**ZONING CHANGE REVIEW SHEET**

**CASE:** C14-2016-0115  
2222 Town Lake Circle

**ADDRESS:** 2222 & 2400 Town Lake Circle and 2217 & 22225 Elmont Drive

**REQUEST (ERC PLAN AMENDMENT):**

This map shows allowable building heights on a parcel without a development bonus.

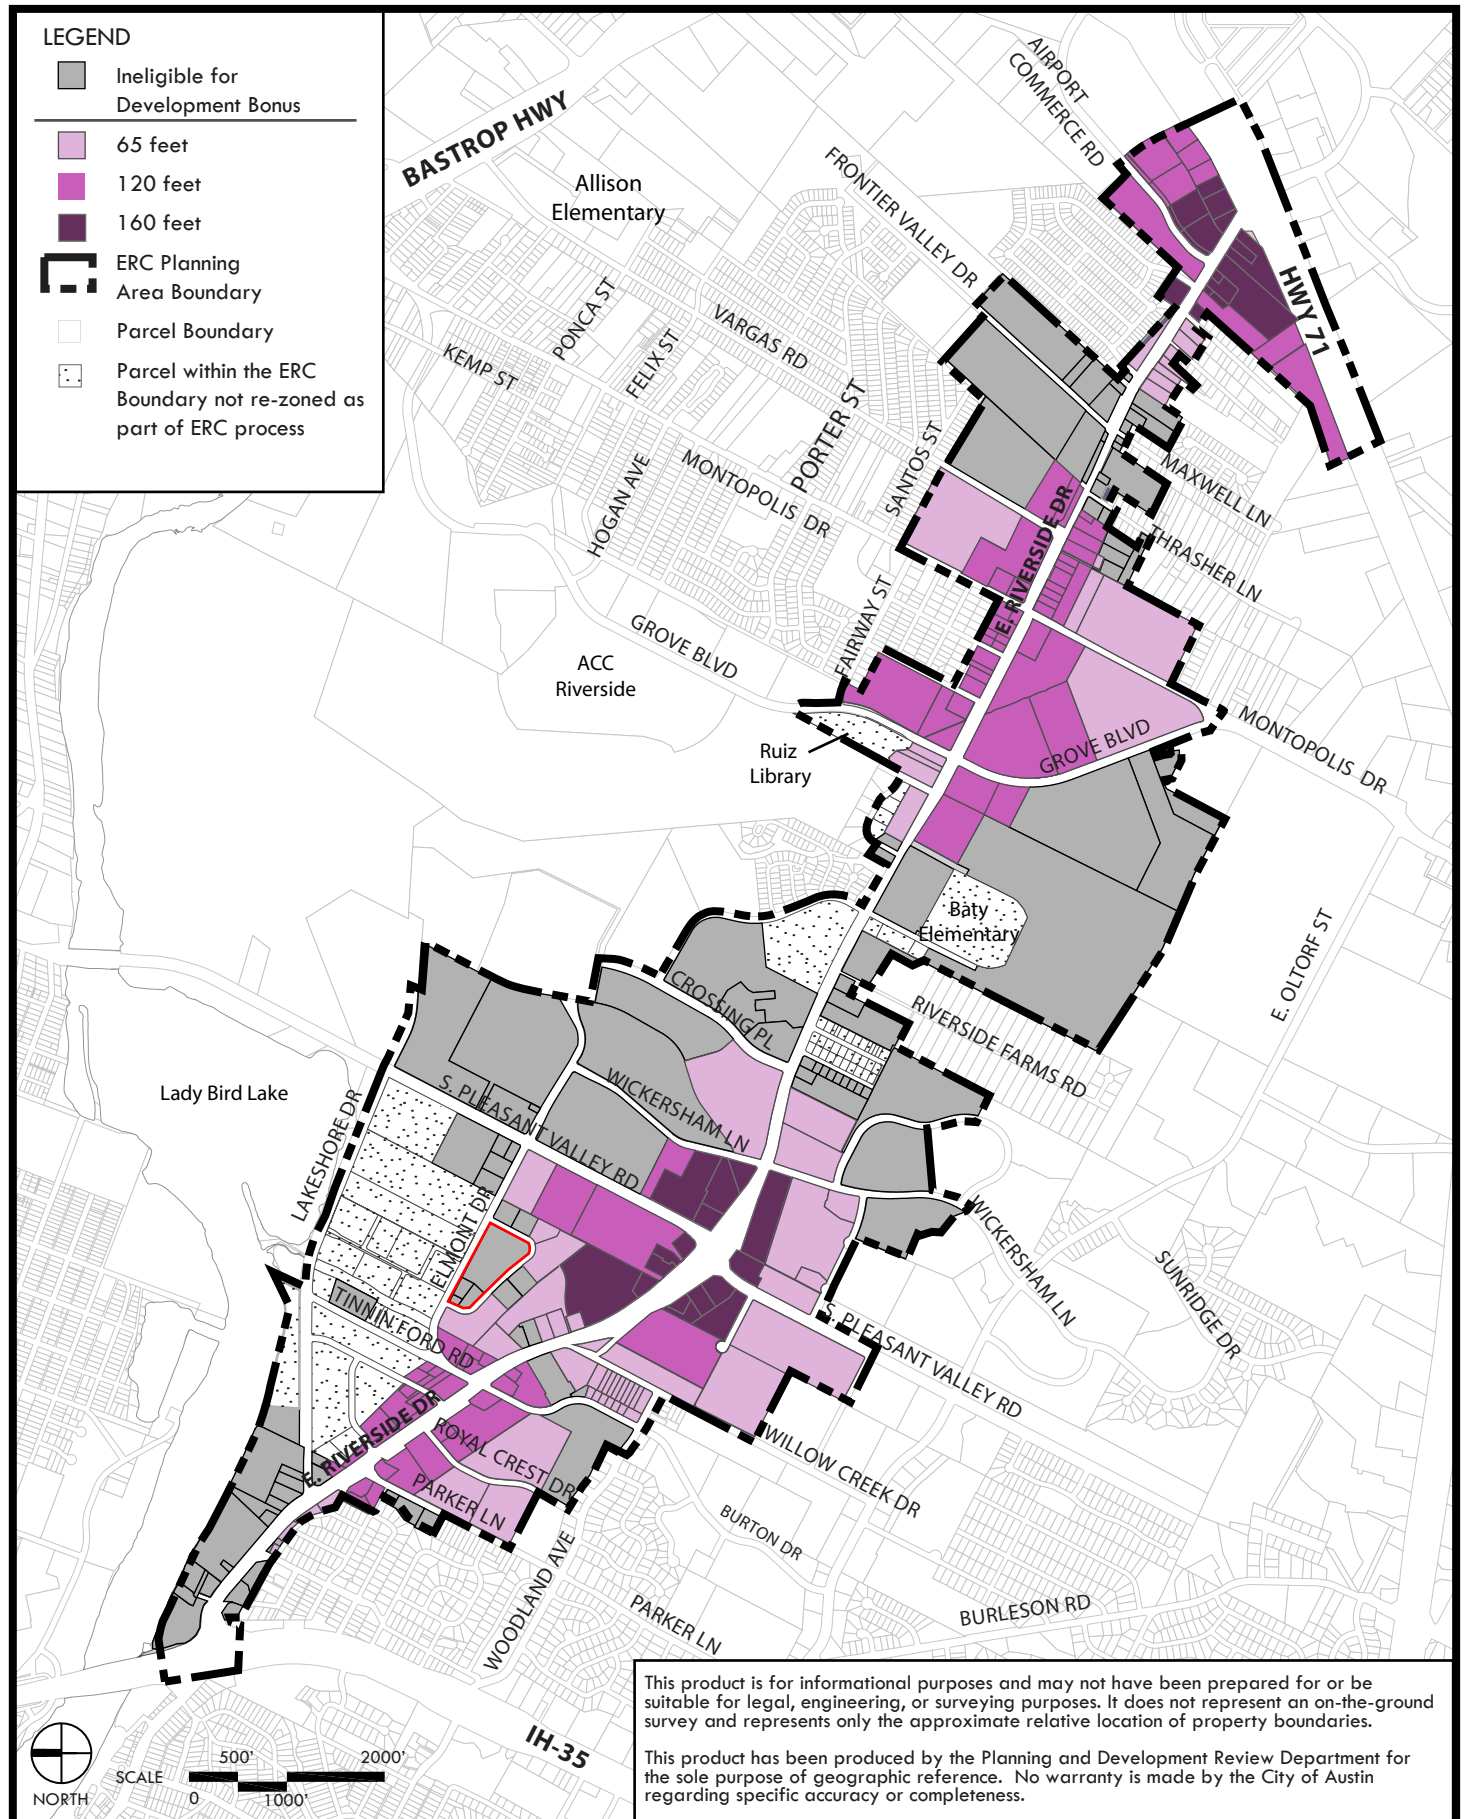
Figure 1-7, East Riverside Corridor Height Map – without a development bonus (see Exhibit C-7) would also be updated to reflect the CMU designation, if so granted. This Plan Figure is illustrative of the subdistrict site development standards, and is not regulatory as are other Plan exhibits; the subdistrict designations on Figure 1-2 are reflected, and controlling over the heights depicted in Figure 1-7, but not the other way around.
